# **8XC196KD COMMERCIAL APPLICATION SPECIFICATION UPDATE**

Release Date: May, 1997  
Order Number: 272833-002

The 8XC196KD may contain design defects or errors known as errata. Characterized errata that may cause the 8XC196KD's behavior to deviate from published specifications are documented in this specification update.

### **9600002.    *Write Cycle During Reset***

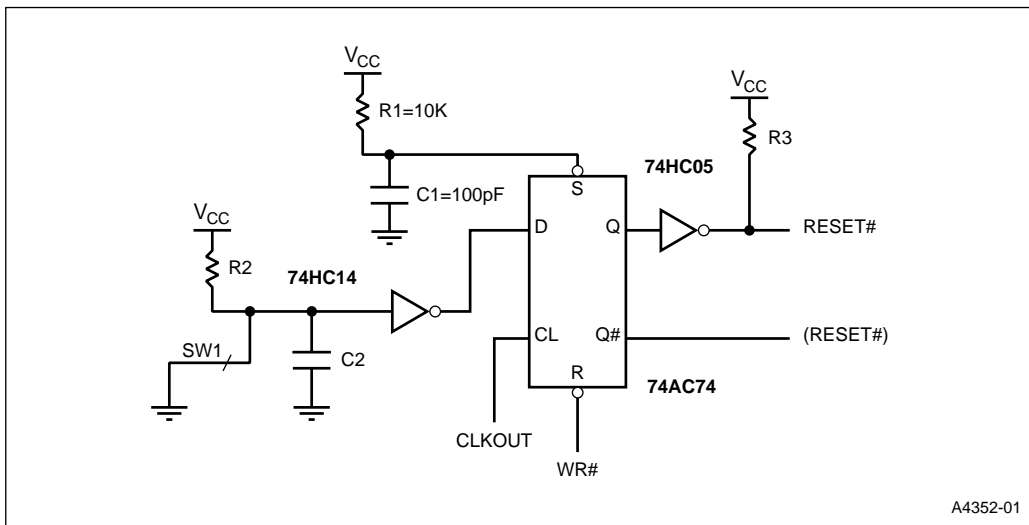
**PROBLEM:** The data bus floats asynchronously with RESET#. If reset occurs during an external write cycle, the contents of the external device may be corrupted. This is the normal operating condition for reset, and is not considered a bug. It is included on this list for those customers that may encounter corruption of data in external RAM during reset.

**WORKAROUND:** Allow reset to occur only at the rising edge of CLKOUT and only if WR# is high. If a reset occurs during an external bus write cycle, RAM data on the external bus may be corrupted. This describes a logic design that will alleviate the problem.

The following circuit will allow a manual Reset to occur at the rising edge of CLKOUT only if WR# is high (inactive). If WR# is low (active) then RESET# will stay 'high' (inactive). The 74HC14 and 74HC05 are usually already in the system, so the only additional components are the 74AC74, R1, and C1.

1.  $R1 = 10K$  and  $C1 = 100 \text{ pF}$ .
2.  $R2$  and  $C2$  should allow for Reset state times plus write wait states.

The  $R1 \cdot C1$  time constant is one microsecond to ensure that the flip-flop comes up 'on' after a power-up. The reset flip-flop at the rising edge of CLKOUT after the  $R2 \cdot C2$  time constant has expired.

For manual resets, the flip-flop will turn on at the next rising edge of CLKOUT unless WR# is low. If WR# is low, the flip-flop turn on will be delayed until the next rising edge of CLKOUT when WR# is not low. This may occur after any number of wait states. The  $R2 \cdot C2$  time constant must be long enough for the normal reset state times plus the maximum number of write wait states.

**006. Page 11-3**

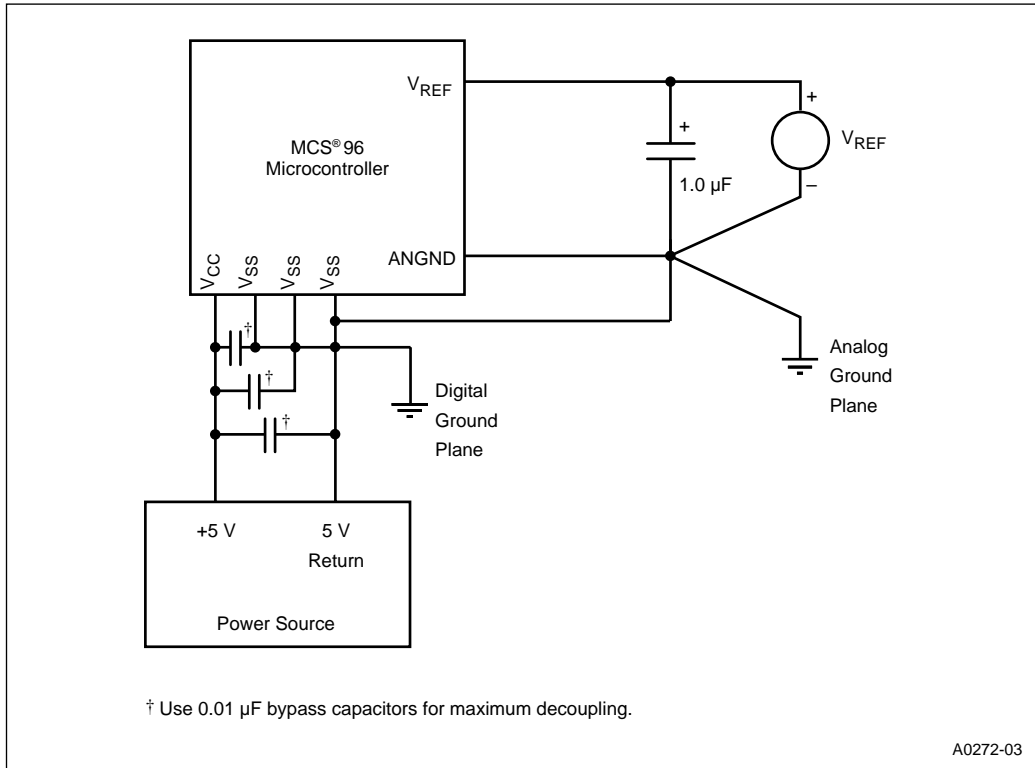
**PROBLEM:** In Figure 11-2, the recommended capacitor value between  $V_{CC}$  and  $V_{SS}$  is  $0.01\ \mu\text{F}$  or greater. Also the recommended capacitor value between  $V_{REF}$  and  $\text{ANGND}$  is  $1.0\ \mu\text{F}$ .

In Section 11.2.1 the reason for these capacitors is explained. However, the second to last line of the first paragraph should read as follows:

'Connect a  $0.01\text{-}\mu\text{F}$  bypass capacitor between  $V_{CC}$  and each  $V_{SS}$  pin and a  $1.0\text{-}\mu\text{F}$  capacitor between  $V_{REF}$  and  $\text{ANGND}$ .'

**024. Page 11-1**

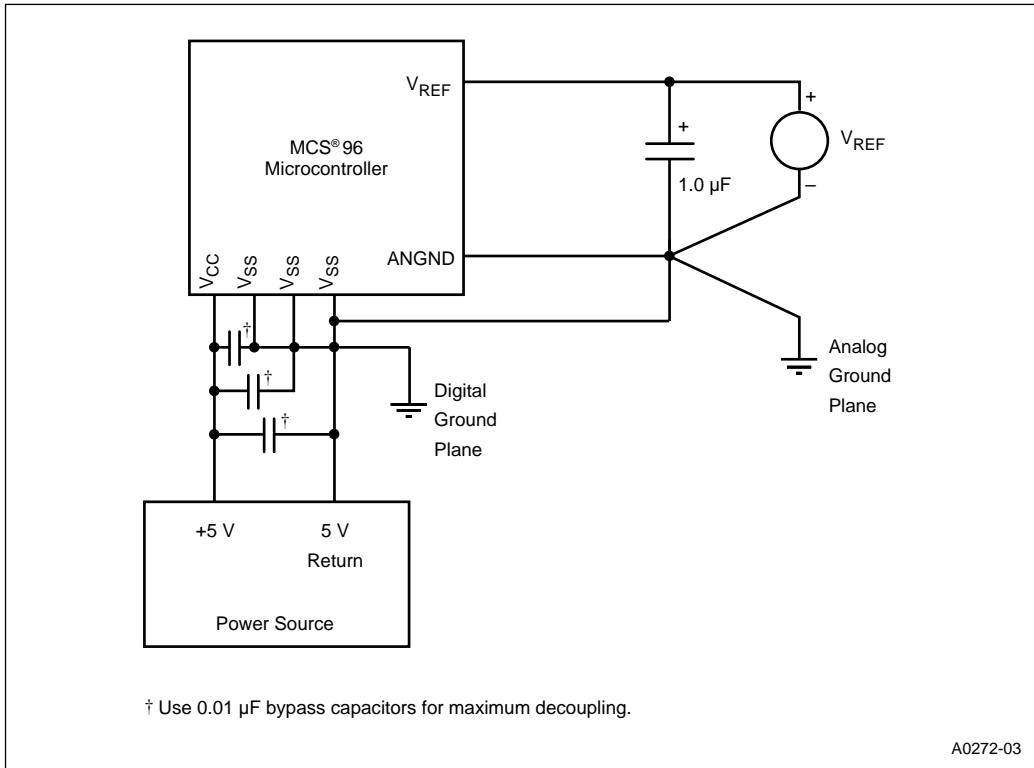
**ITEM:** The last sentence in Section 11.1 should read: . . . **'Figure 11-1'** not Figure 14-1.

Figure 11-6. External Clock Drive

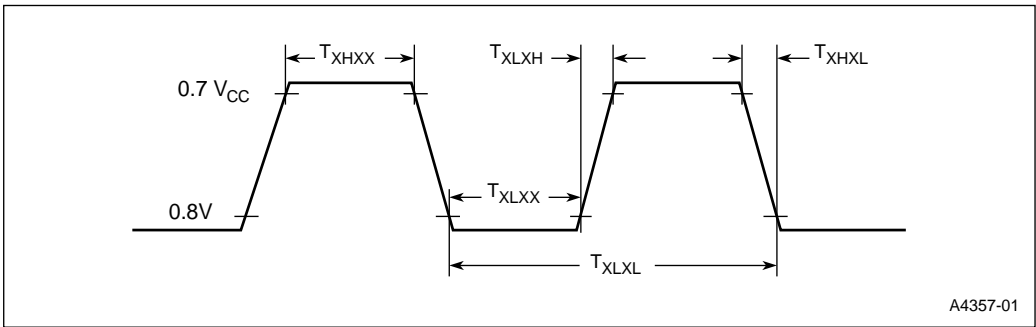
**ITEM:** In Figure 11-6, the timing diagram incorrectly represents the  $T_{x|xl}$  and  $T_{xhx|}$  timing specifications. The timing diagram below replaces Figure 11-6.

Figure 11-8. Reset Pin Internal Circuit

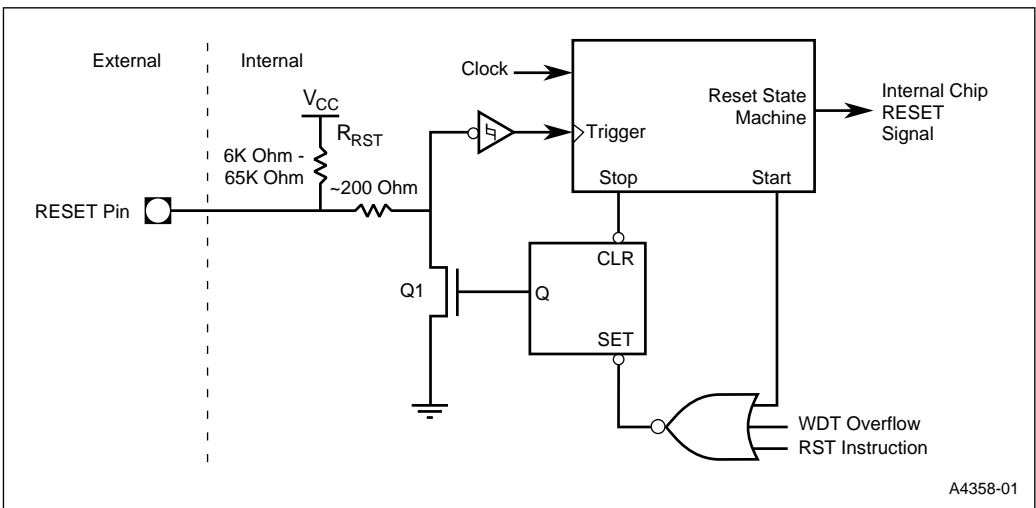
**ITEM:** Figure 11-8 shows the reset pin internal circuit. However, there are a couple of mistakes; the following figure shows the corrected version. The **inverter** at the Reset State Machines Trigger input and the **OR gate** at the SET input of the latch are the corrections to this figure.
